Addendum

SPRINGS AT FREMAUX TOWN CENTER
SLIDELL, LA

DRAWING TITLE FIRST FLOOR PLAN - CLUBHOUSE

1 FIRST FLOOR PLAN - CLUBHOUSE
SCALE: 1/4"=1'-0"
NORTH

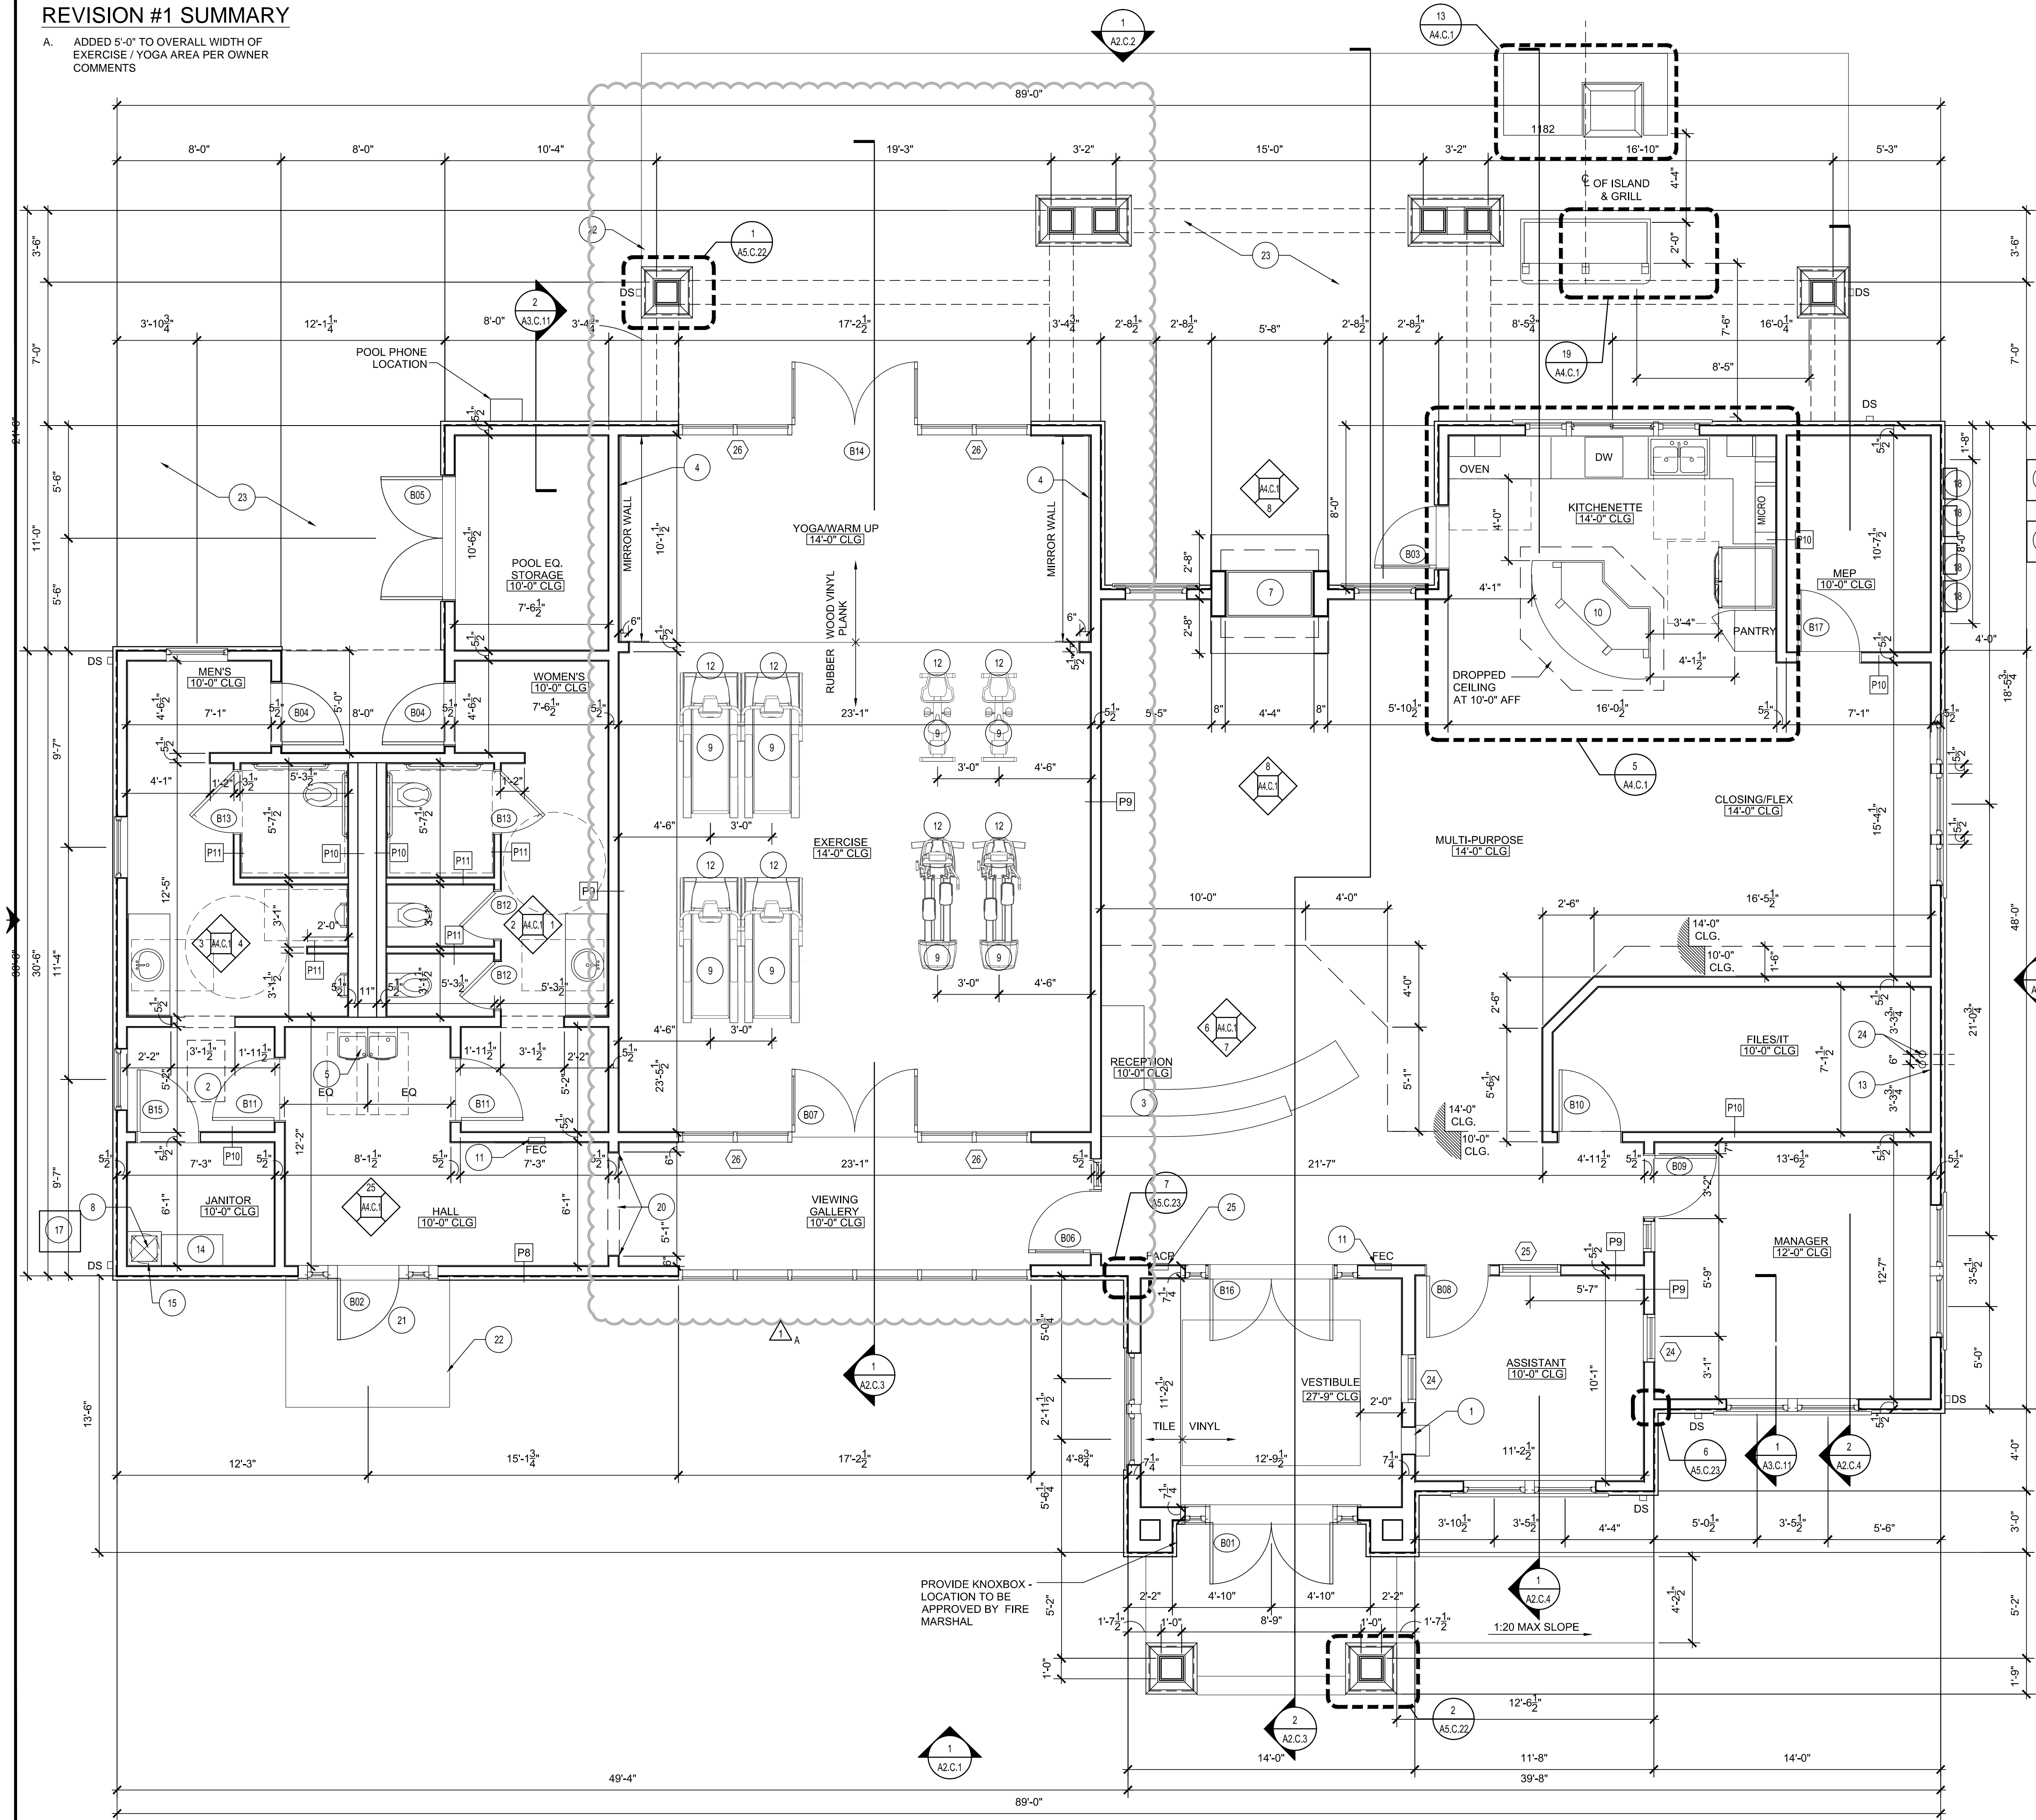
A. ADDED 5'-0" TO OVERALL WIDTH OF EXERCISE/YOGA AREA PER OWNER COMMENTS

1 ROOF PLAN - CLUBHOUSE SCALE: 1/4"=1'-0"

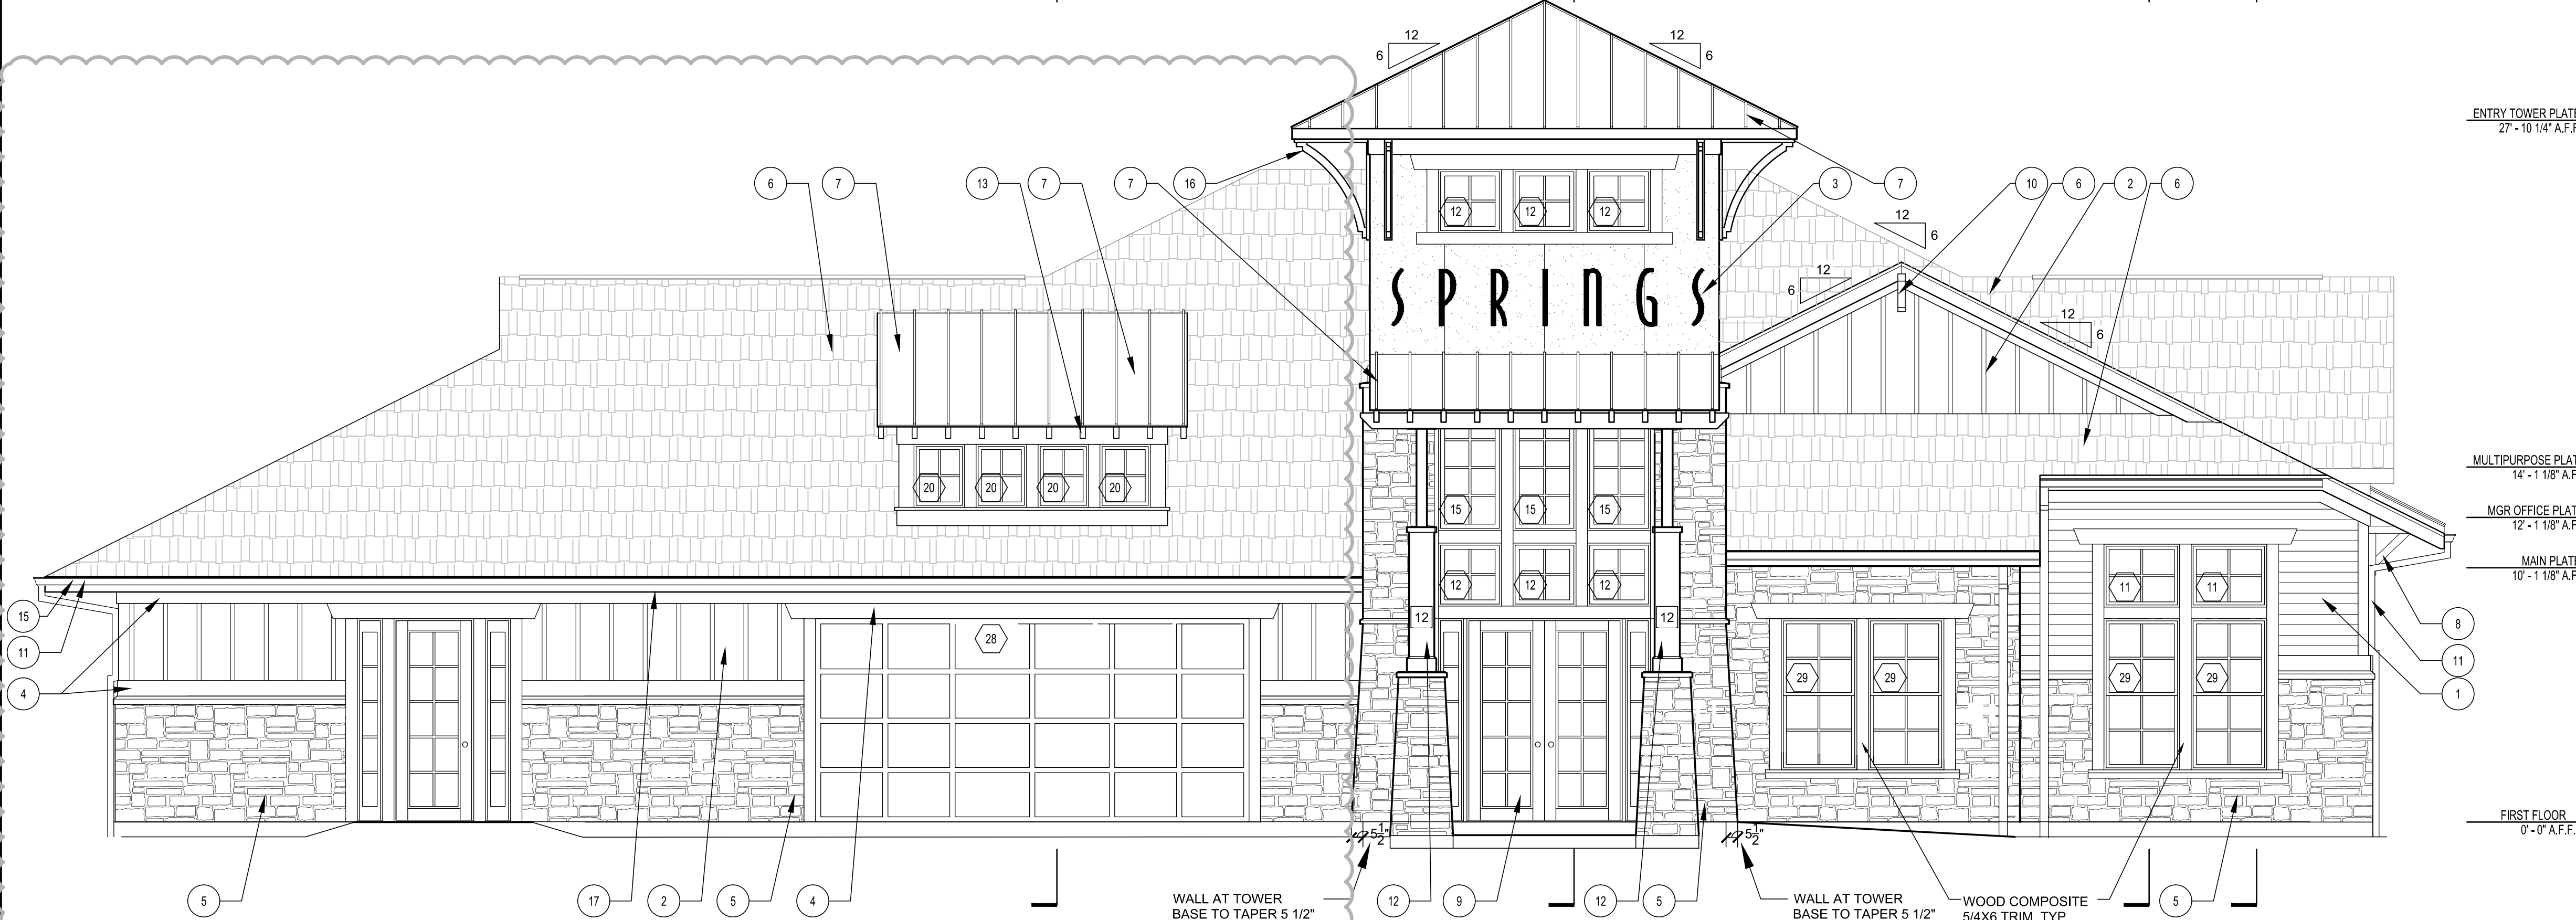
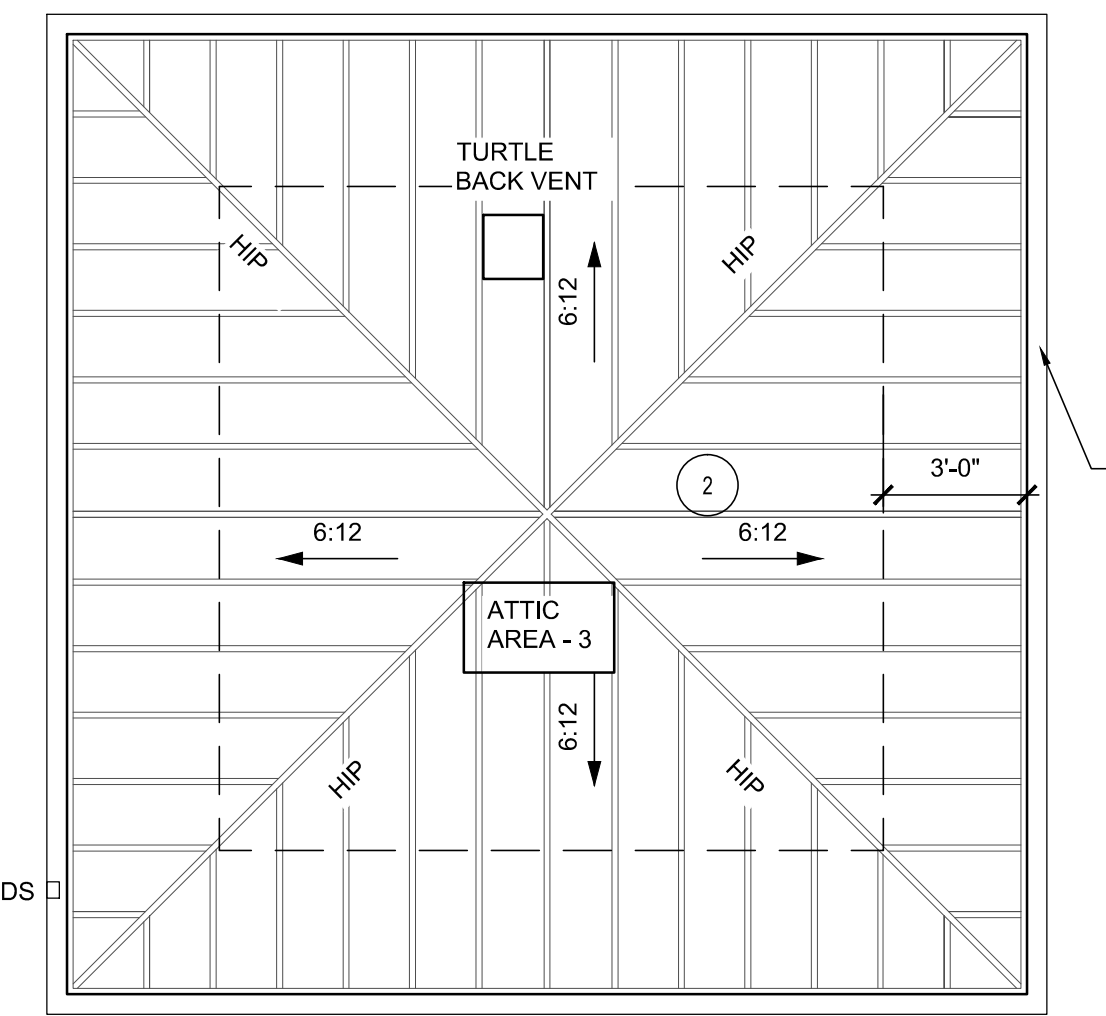
- UPDATED ROOF PLAN TO SHOW CORRECT LOCATIONS OF METAL ROOFING
- CLARIFIED RIDGE VENT COLOR
- ADDED ATTIC AND ROOF AREA TO AREA #1 TO COORDINATE WITH ADDITIONAL FLOOR AREA
- UPDATED ATTIC VENTILATION SCHEDULE FOR ADDITIONAL ATTIC AND ROOF AREA
